DESIGN REVIEW BOARD WORK SESSION

**Design Review Board Case # 20-0001
Block P – 765 John Carlyle**

Application	General Data	
Project Name: 765 John Carlyle Location: Block P – Carlyle CDD Applicant: Carlyle Plaza, LLC c/o McGuireWoods LLP	DRB Date:	June 22, 2020
	Site Area:	Block P – Carlyle CDD
	Zone:	CDD #1
	Proposed Use:	Office / Senior Living
	Gross Floor Area:	To be provided
<p>Purpose of Application: Review of the conceptual architecture for Block P, Carlyle area.</p>		
<p>Staff Reviewers: Robert M. Kerns, AICP robert.kerns@alexandriava.gov Thomas H. Canfield, AIA tom.canfield@alexandriava.gov Nathan Imm Nathan.imm@alexandriava.gov Carson C. Lucarelli carson.lucarelli@alexandriava.gov</p>		
<p>DRB ACTION FROM JUNE 22, 2020 WORK SESSION – SUMMARY: The DRB unanimously approved the concept submission for the north tower and podium at 765 John Carlyle with a vote of 5-0. This project was previously heard by the DRB during 2006 and 2007, receiving approval for the Design Concept in May 2007. Additional approvals were obtained in July and September 2007, for final design of materials with conditions, and for treatment of parking garage and building top accordingly. The project as

WMATA Virginia HQ office building (**Figure #2** below)

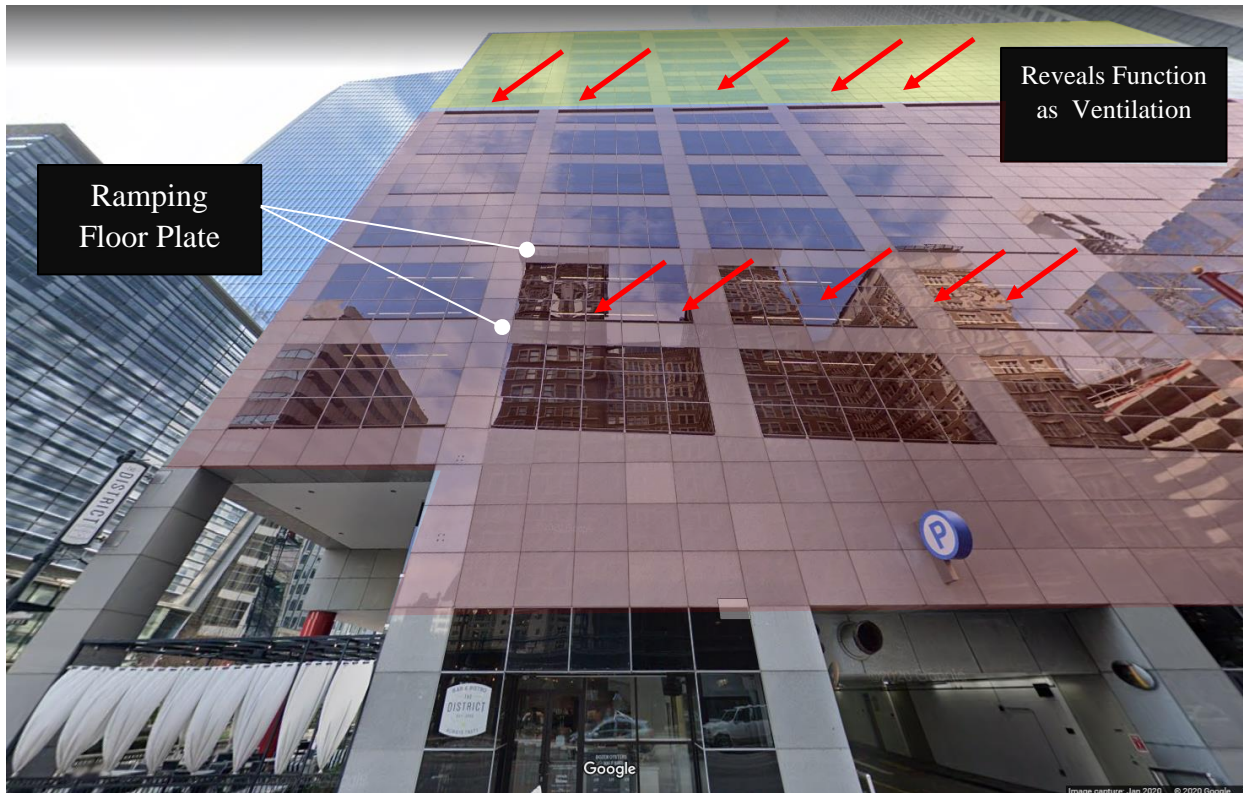
Option #1: One potential technique is to carry some percentage of glazing and other cladding from the occupied levels above, down through the parking skin. More specifically, a narrower glass panels on the north tower, and the ladder-mullioned side panels on the south tower. Examples of this are shown below, the first from the previous approval for this site (“Block P”) and the second from the recently approved and now under construction Previous Design for Block P – Integration of Glazing into Garage Levels (**Figure #1** below):

In both of these examples, the garage function is legible, but its presence is suppressed visually through the continuation and integration of high-quality façade elements from the main body of the tower above into the parking level facades.
